## **MCRAE PLACE SUBDIVISION**

APPLICATION NUMBER 18 DATE May 19, 2005

APPLICANT McRae Place Subdivision

REQUEST Subdivision

# DETAIL SITE PLAN

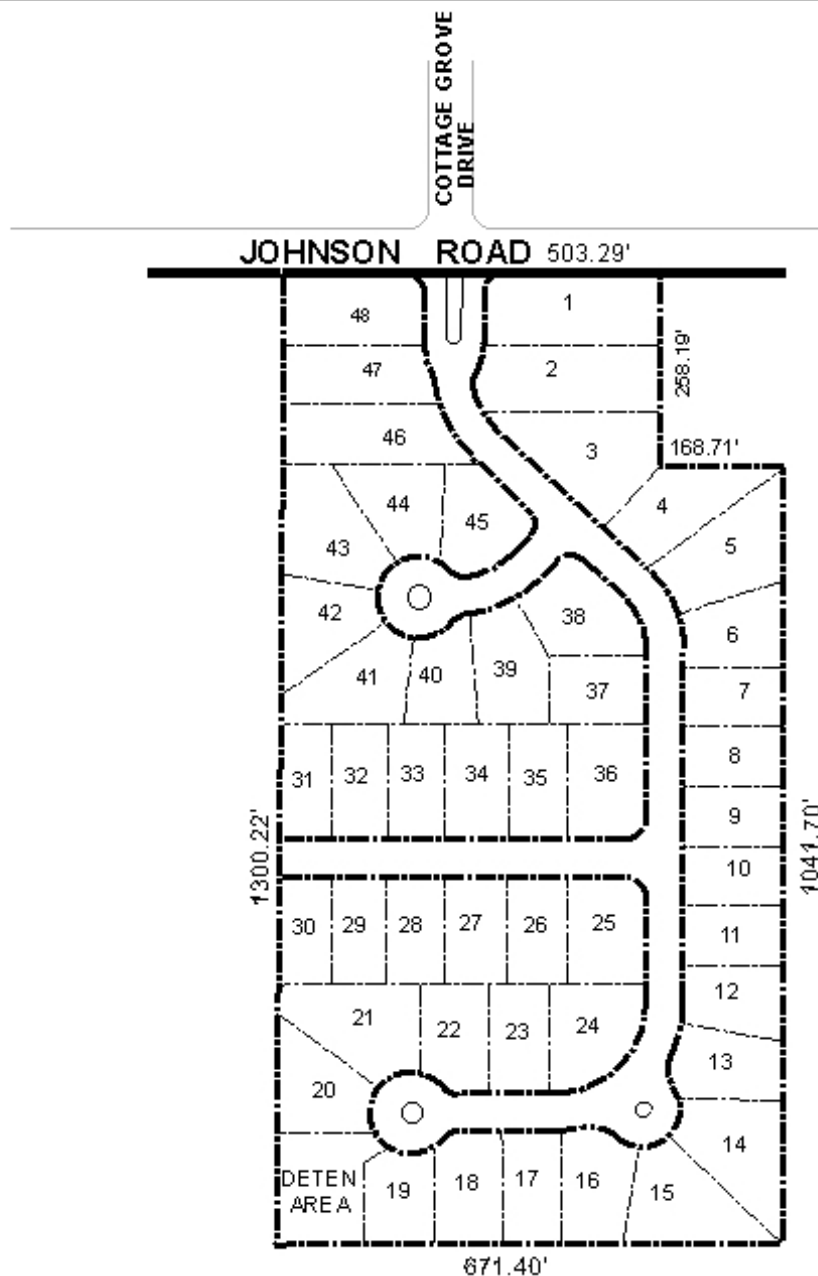
The site fronts Johnson Road, a minor street with an existing 60-foot wide right-of-way. As a means of access management, a note should be placed on the final plat stating that Lots 1 and 48 are denied direct access to Johnson Road.

This subdivision application involves the creation of new streets; all new streets should be constructed to County Engineering standards and dedicated to the County. As the site abuts large undeveloped parcels to the east and south, street stubs to the east and south should be required. The Spring Brook subdivision to the west, as condition of its approval, required a street stub to the east; the developer of the Spring Brook Farms, Phase One subdivision has already platted the area where this application proposes a street stub, and a home is already under construction at the proposed street stub location, as verified by County Engineering. Therefore, the applicant should revise the proposed McRae Place subdivision so that the street stub to the west is located in the vicinity of lot 20, instead of between lots 30 and 31.

The required 25-foot building setback lines are not shown but would be required on the final plat.

The islands within the roadways should be labeled as common areas, and a note should be placed on the final plat stating that the maintenance of the common areas and detention area shall be the responsibility of the property owners. Additionally, the site is located in the County; thus any lots that are developed commercially and adjoin residentially developed property must provide a buffer, in compliance with Section V.A.7 of the Subdivision Regulations.

With modifications, the plat will meet the requirements of the Subdivision Regulations, and is recommended for Tentative Approval, subject to the following conditions: 1) the placement of a note on the final plat stating that Lots 1 and 48 are denied direct access to Johnson Road; 2) the provision of street stubs to the East and South, and a revised street stub to the West near lot 20 to connect with Spring Brook Farms, Phase One; 3) the construction and dedication of the new streets; 4) the depiction of the 25' building setback lines on the final plat; 5) labeling of all islands within the roadways as common areas; 6) the placement of a note stating that

maintenance of common areas and the detention area shall be the responsibility of the property owners; and 7) the placement of a note on the final plat stating that any lots that are developed commercially and adjoin residentially developed property must provide a buffer, in compliance with Section V.A.7 of the Subdivision Regulations.
